General Grounds Improvements for Barton Springs Pool

Waterfront Planning Advisory Board

February 11, 2013

Barton Springs Pool – General Grounds Improvements

Existing Conditions Analysis Plan

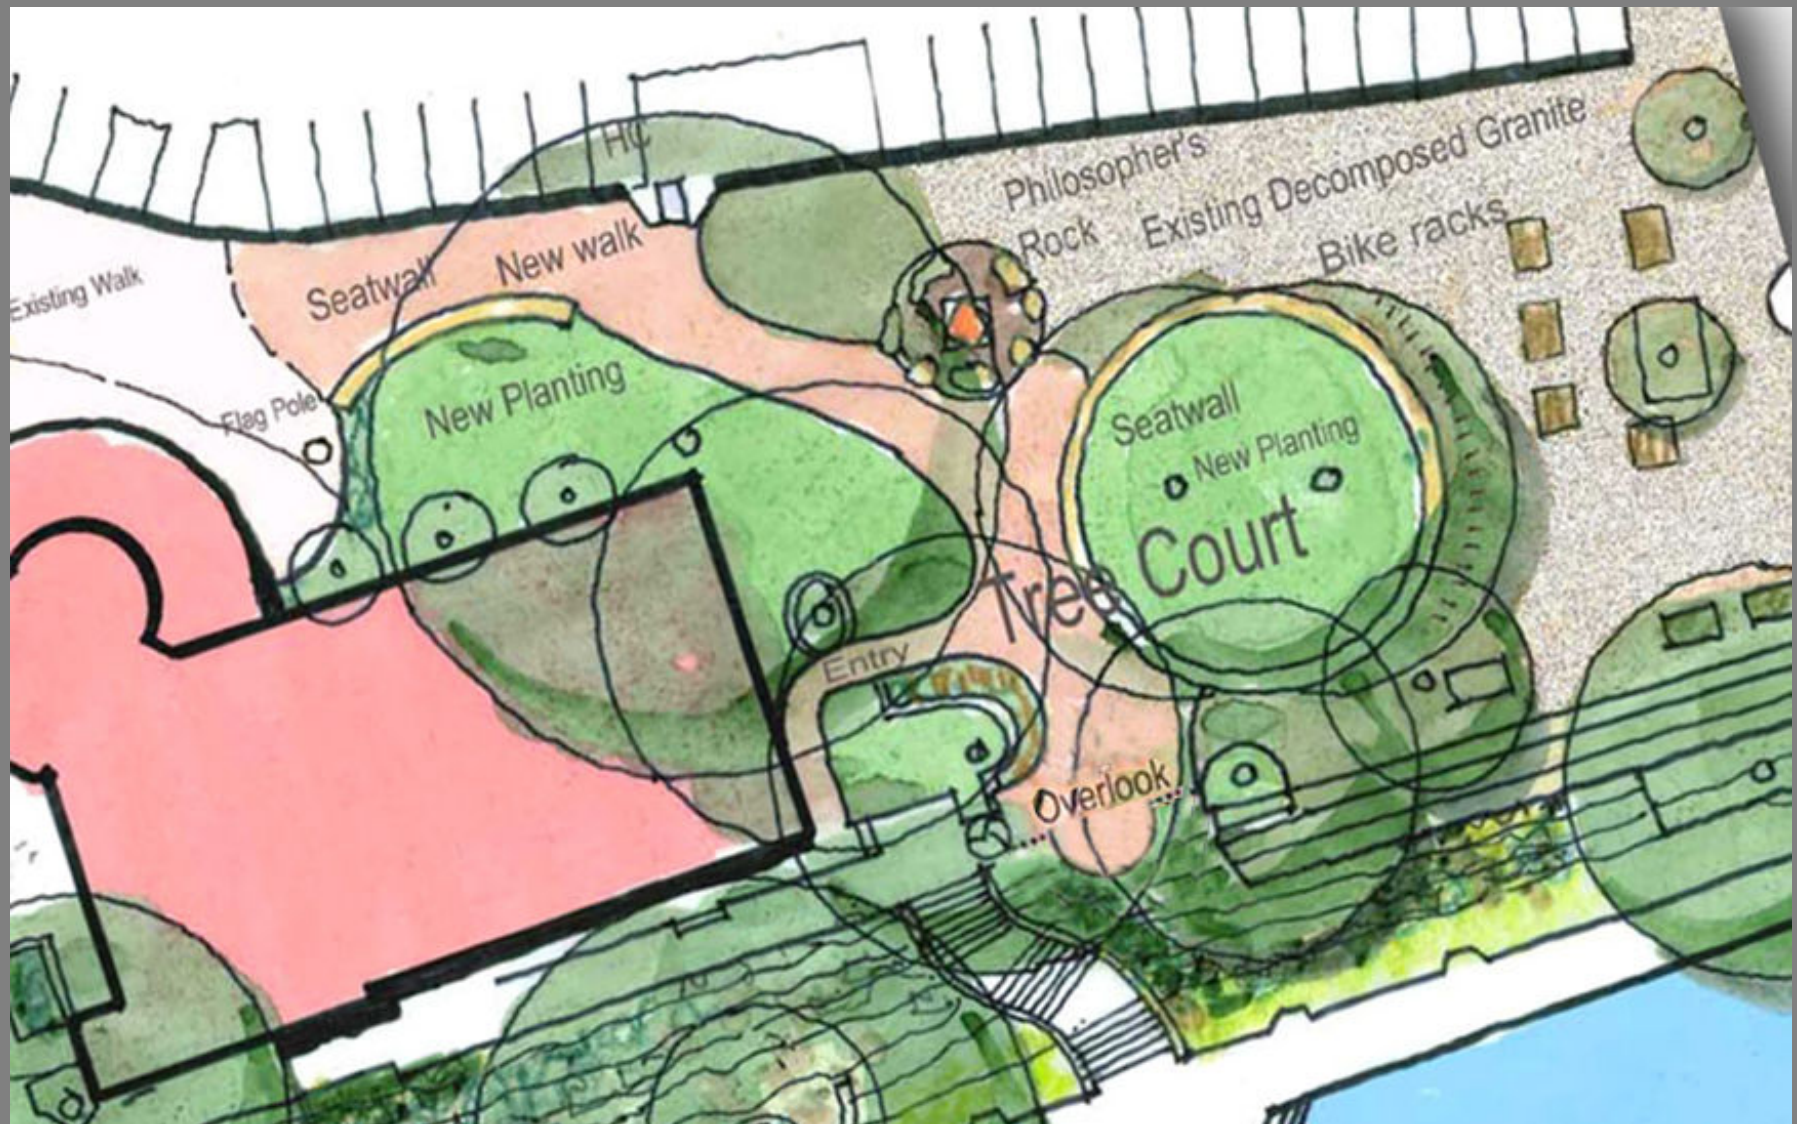
1. *Tree Court Area:*
 - a. *The entire tree court area is treated as a Critical Root Zone;*
 - b. *Decomposed granite is removed from root zone areas and under walks to native grade;*
 - c. *Piers for the suspended walk are excavated with an air excavation tool for the first 2';*
 - d. *Soil beneath the suspended walk is de-compacted after piers are poured;*
 - e. *An approved Certified Arborist or appropriate city staff be present during construction.*
2. *Remove the south overlook and pathway to the overlook from the plan.*
3. *Increase size of planting median in south parking lot area to 4000 SF and reduce the large maturing trees in the planting to two trees.*
